Index 700-120 Electronic Display Sign - Roadside Flashing Beacons

COMMENTARY

COMMENTS AND RESPONSES

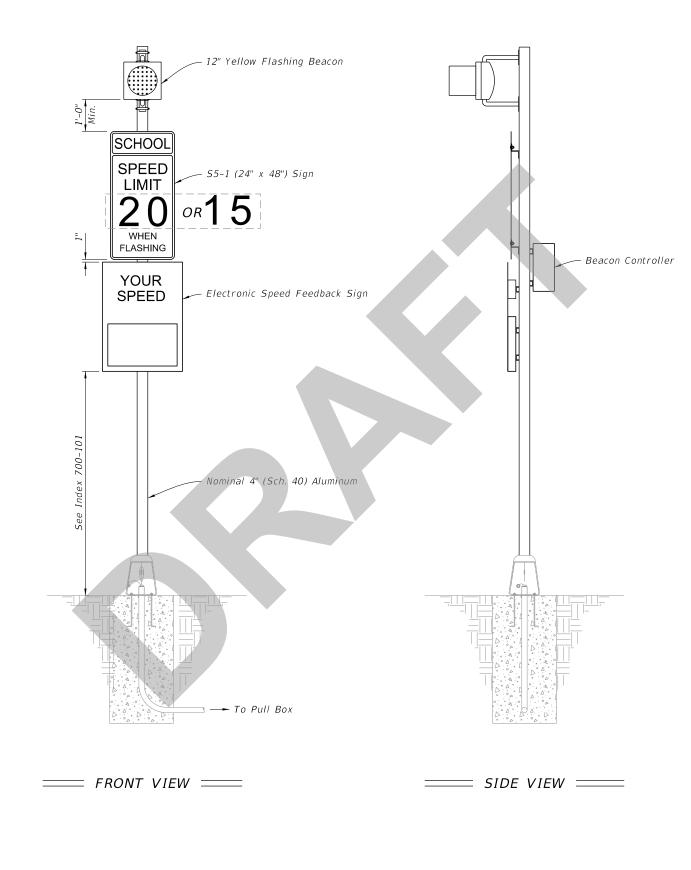
Change 40s to 45. Otherwise, the usage window gets a little narrow.

Changed "speeds greater than 40 mph" to "speeds greater than 45 mph" on Note 2, Sheets 5, 7, and 8.
